TSG-RAN Working Group 1 meeting #10          **TSGR1#10(00)0065**
Beijing, China
January 18 – January 21, 2000

**Title:**     CR 25.215-032: Clarification of compressed mode parameters

| **25.215** | **CR** | **032** | Current Version: | 3.1.0 |

**Subject:**   Corrections to 25.215 compressed mode parameter list

*Figure 1 : illustration of compressed mode pattern parameters*

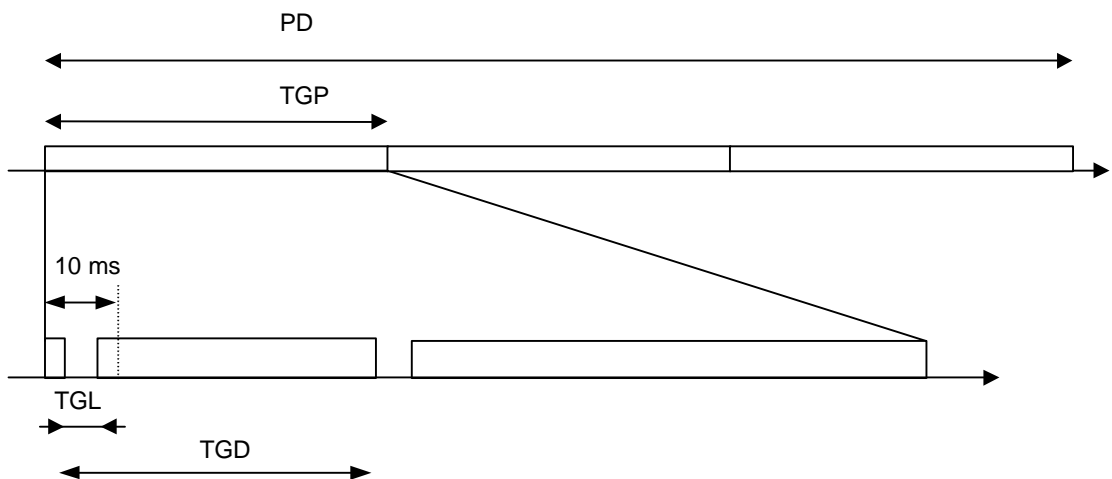
For doing some measurements, e.g. FDD-FDD interfrequency cell search, the transmission gap distance (TGD) has to be set to fractions of full frames to provide optimum performance. Thus, it is proposed to change it to number of slots instead number of frames.

**Reason for change:**   For FDD-FDD interfrequency measurements, the transmission gap distance (TGD) needs to be expressed in slots, not in frames. Some parameters were listed twice. Some parameters were not clarified to be integers.

- TGP : Transmission Gap Period is the period of repetition of a set of consecutive frames containing up to 2 transmission gaps (*).
- TGL : As defined above
- TGD : Transmission Gap Distance is the duration of transmission between two consecutive transmission gaps within a transmission gap period, expressed in number of slotsframes. In case there is only one transmission gap in the transmission gap period, this parameter shall be set to zero.
- PD: Pattern duration is the total time of all TGPs expressed in number of frames.
- SFN : The system frame number when the first transmission gap starts

The parameters SFN, SN, TGL, TGD, TGP (or TGP1, TGP2) and PD shall all be integers.
